**Approval for
Phase 3 only at
this time.**

GRANITE RIDGE SUBDIVISION
PHASE 3/4
PART OF THE SOUTHEAST QUARTER OF SECTION 26,
TOWNSHIP 8 NORTH, RANGE 2 WEST,
SALT LAKE COUNTY, UTAH
MILLARD, UTAH
INDEX SHEET

GRANITE RIDGE SUBDIVISION
PHASE 3/4

GRANITE RIDGE SUBDIVISION
PHASE 3/4
PART OF THE SOUTHEAST QUARTER OF SECTION 26,
TOWNSHIP 8 NORTH, RANGE 2 WEST,
SALT LAKE BASELINE AND MERIDIAN
WILLARD, UTAH
GRADING/DRAINAGE PLAN PG2

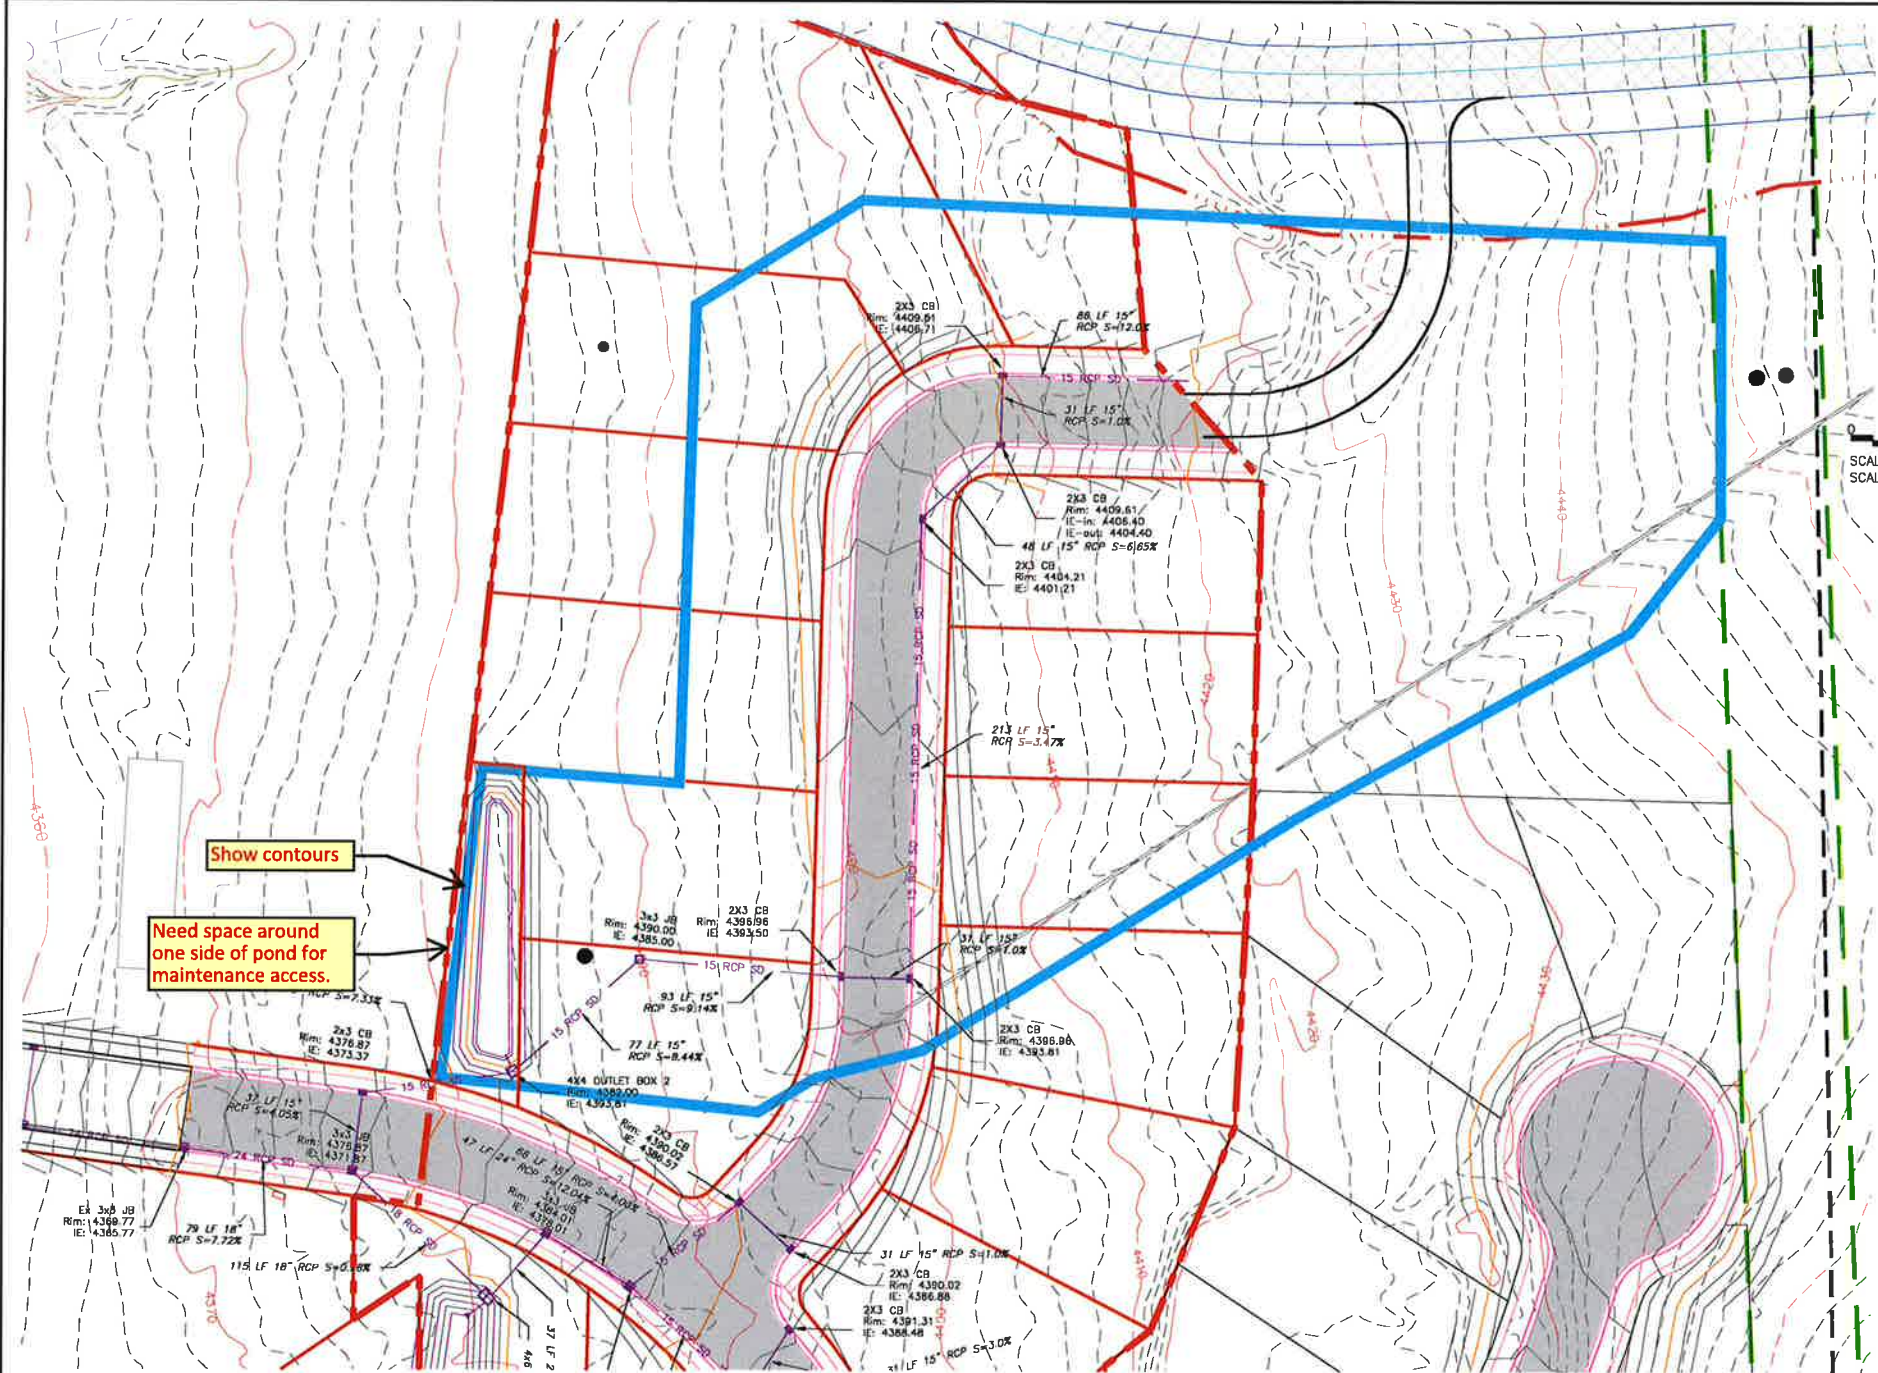
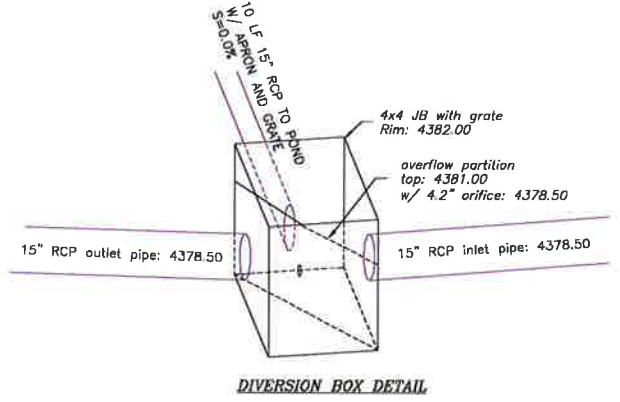
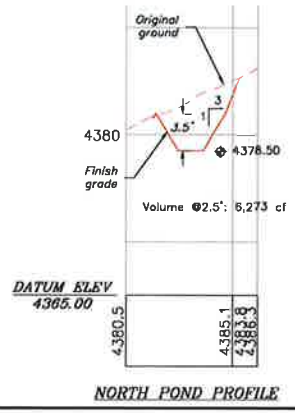
Show contours
Need space around one side of pond for maintenance access.

1. Show drainage areas/calcs for both ponds.
2. Show pond volumes on plans
